1997 - 1999 Corvette: Service Bulletin: Chime Sounds When Key is Removed from Ignition

Subject: Chime Sounds When Key is Removed from Ignition, Intermittent Operation of Power Door Locks, Keyless Entry, Steering Column Lock or Memory Seats (Inspect/Replace Lock Cylinder Actuator or Lock Cylinder Assembly)

Number: 99-08-49-008

- (1) Installed Position of the Ignition Lock Cylinder
- (2) Location of the Release Plunger (tab) at the 4 o'clock position

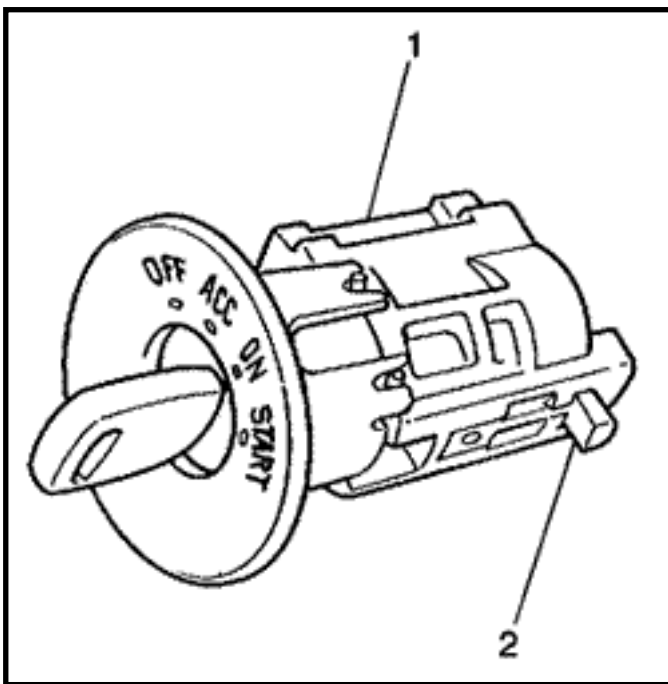
The actuator, located in the ignition lock cylinder, may be sticking after the key is removed.

Remove the ignition lock cylinder for the instrument panel using the following procedures. Once removed from the vehicle, use the "Actuator Type Identification" and "Test Procedure" sections later in this bulletin to determine the correct repair procedure.

- (1) Early Design Actuator in the Lock Cylinder
- (2) Side View of the Early Design Actuator When Removed from the Lock Cylinder
- (3) New Design Actuator in the Lock Cylinder
- (4) Side View of the New Design Actuator When Removed from the Lock Cylinder

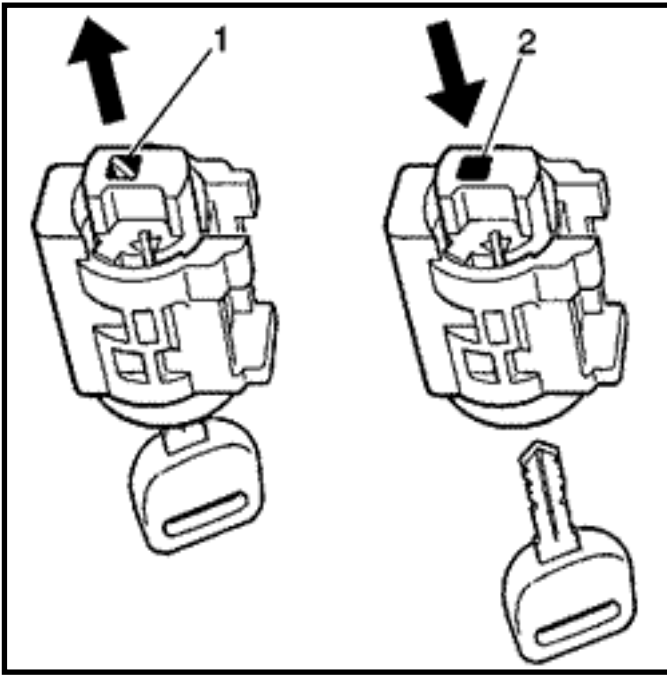
With the key installed, hold the lock cylinder as shown in Figure 2 to determine what type of actuator is being used. FOLLOW THE APPROPRIATE TEST PROCEDURE FOR THE TYPE OF ACTUATOR BEING USED.

1. With the lock cylinder held vertically as shown in Figure 3, remove the key from the lock. When the key is removed, the actuator should drop down in the lock cylinder approximately 4-5 mm (3/16 in). Repeat this step several times.
2. If the EARLY design actuator in the lock cylinder does NOT drop down, replace the complete lock assembly.
3. If the EARLY design actuator in the lock cylinder DOES drop down, replace the actuator with the new design actuator P/N 12450483.

1. With the lock cylinder held vertically as shown in Figure 3, remove the key from the lock. When the key is removed, the actuator should drop down in the lock cylinder approximately 4-5 mm (3/16 in). Repeat this step several times.
2. If the NEW design actuator in the lock cylinder does NOT drop down, replace the lock cylinder assembly.
